PLANS AND DOCUMENTS referred to in the PDA DEVELOPMENT APPROVAL

Approval no: DEV2025/1630
Date: 15 July 2025

SITE AND DRAINAGE PLAN

Lot 528, #7 Quest Lane Clinton

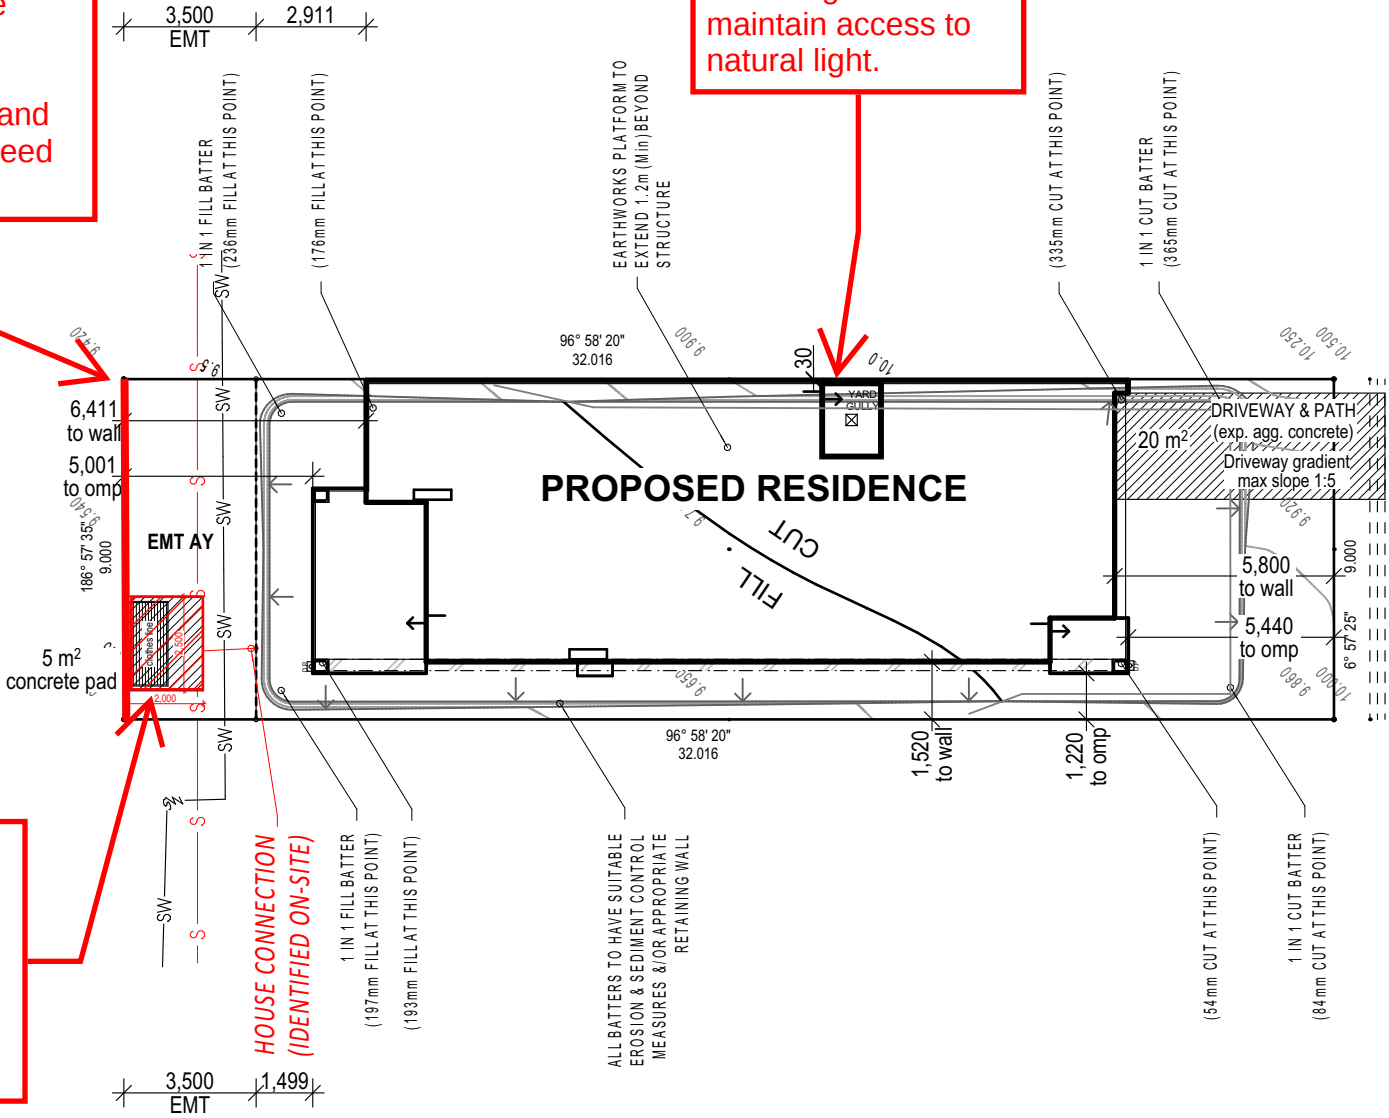
Front fence along the Harvey Road Frontage is required to remain a minimum of 50 percent transparent and is to include a gate for direct pedestrian access from the existing stairs.

Combined height of fence and retaining wall must not exceed 1.8m

Clothes line location not approved.

Clothes line may only be located on side boundary fences.

Light court to remain un-roofed, with no overhangs to maintain access to natural light.

AMENDED IN RED
